FINAL
RADIOLOGICAL REMOVAL ACTION COMPLETION REPORT
Radiological Surveys of Buildings and Ground Surfaces, and
Storm Drain and Sanitary Sewer Removal
Parcel D-1, Phase 1
Hunters Point Naval Shipyard
San Francisco, California

Document Control Number: SHAW-8822-0006-0435

January 2014

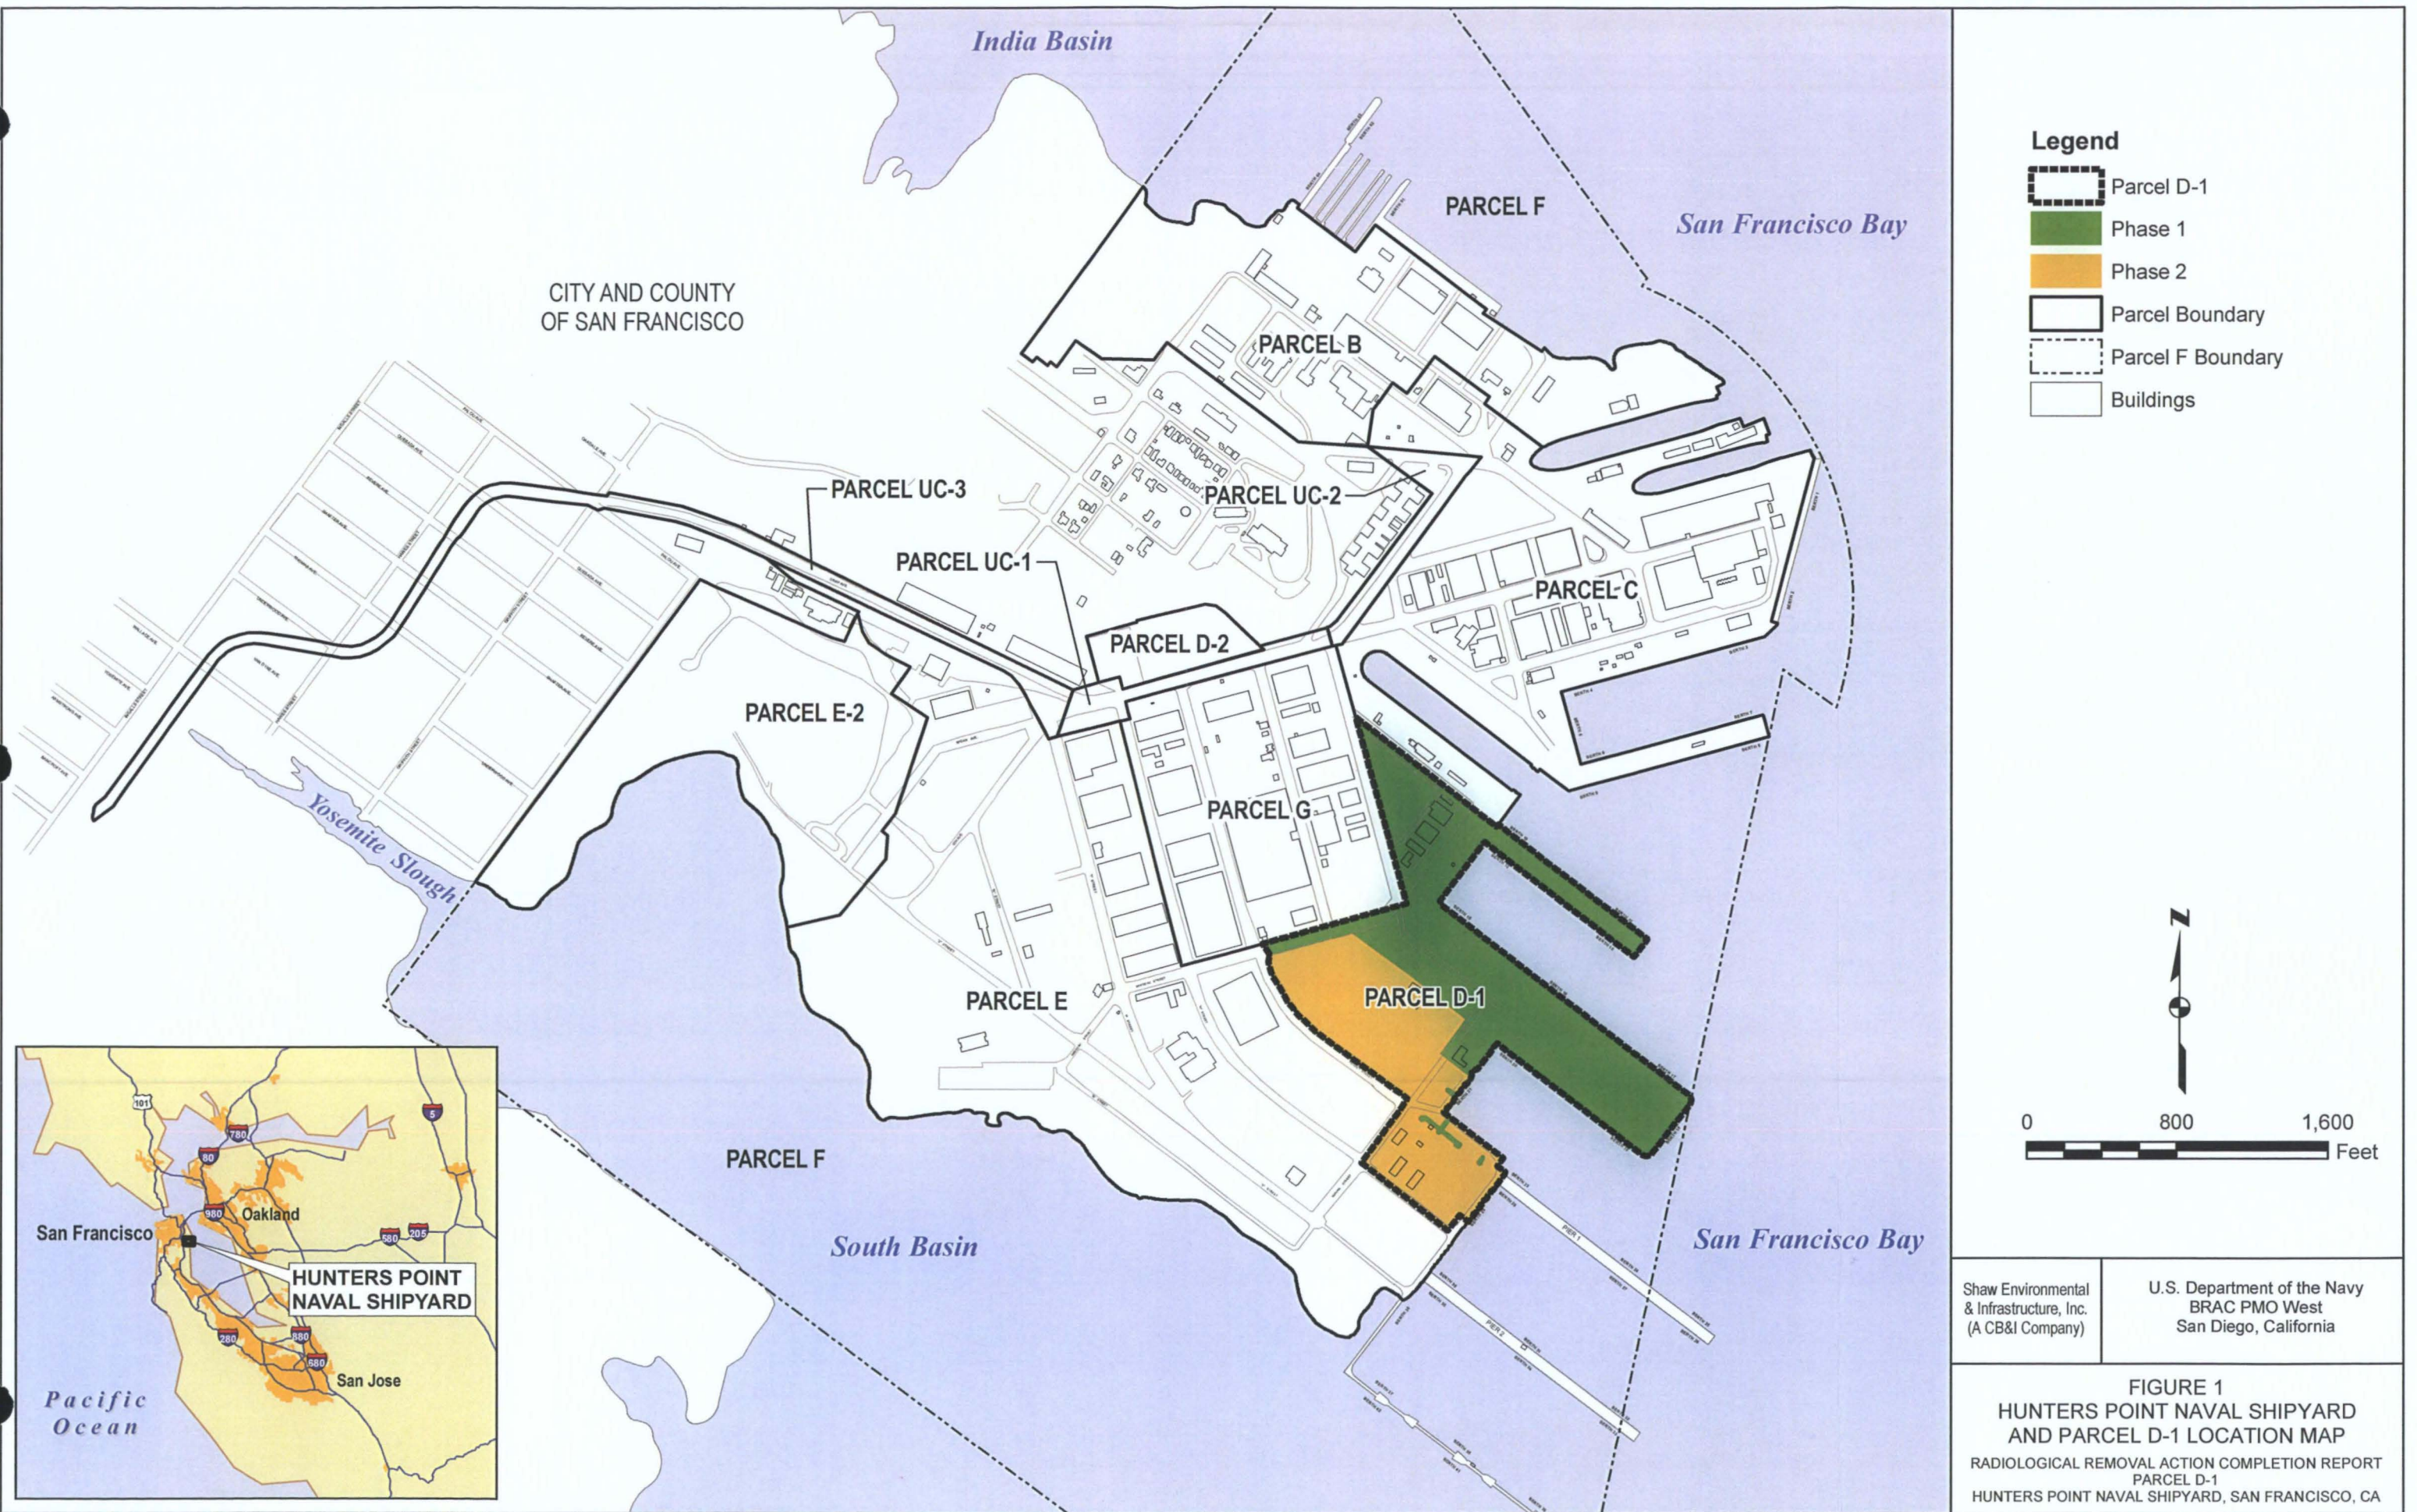
Comment 10. Figure 3 – Project Schedule. This schedule should be updated accordingly.	Response 10. The updated final Phase 1 schedule has been included with the Final RACR.
